Project	IEEE 802.16 Broadband Wireless Access Working Group < http://ieee802.org/16 >	
Title	Proposal on DLFP Format Change for 802.16 OFDM	
Date Submitted	2004-01-27	
Source(s)	Vladimir Yanover, Naftali Chayat, Tal Kaitz (Alvarion Ltd.) , Martin Lysejko (Airspan), John Dring(Intel), Lei Wang (Wi -Lan), Athos Kasapi (ArrayComm), Raja Banerjea, Don Leimer (Proxim), Radu Selea (Redline Comm.)	Voice: +972-36457834 Fax: +972-36456222 mailto:vladimir.yanover@alvarion.com mailto:naftali.chayat@alvarion.com mailto:tal.kaitz@alvarion.com
	21 A Habarzel St. Ramat - Hahayal Tel - Aviv 69710	
Re:	Supporting document for Letter Ballot #13a	
Abstract	The document suggests DLFP Format Change for 802.16 OFDM. Such change allows to fix problem of DL-MAP overhead (that also decreases penalties of certain STC solution), to eliminate special case when MAC PDU is crossing boundary between two PHY bursts and to relax real time problems in DL-MAP parsing

Proposal on DLFP Format Change for 802.16 OFDM

3. DLFP and Regular DL-MAP

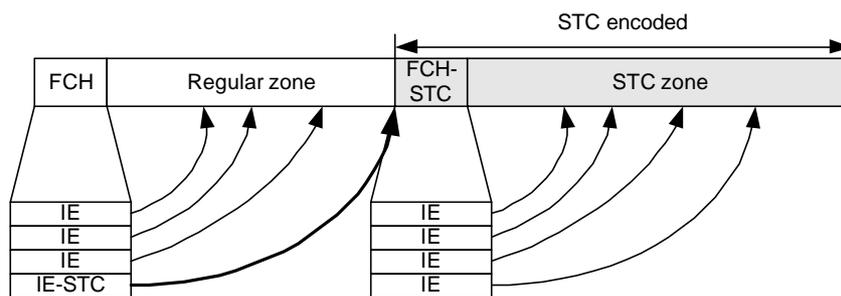
DL-MAP message will still be used, but it will not cross the boundary between FCH and burst #1. Format of DL-MAP is not changed. Bursts specified by DLFP will not be specified in DL-MAP and opposite.

In most cases there will not be more than 4 bursts in the DL, then the only information left to DL-MAP is PHY Sync information (particularly frame number), BS ID etc.
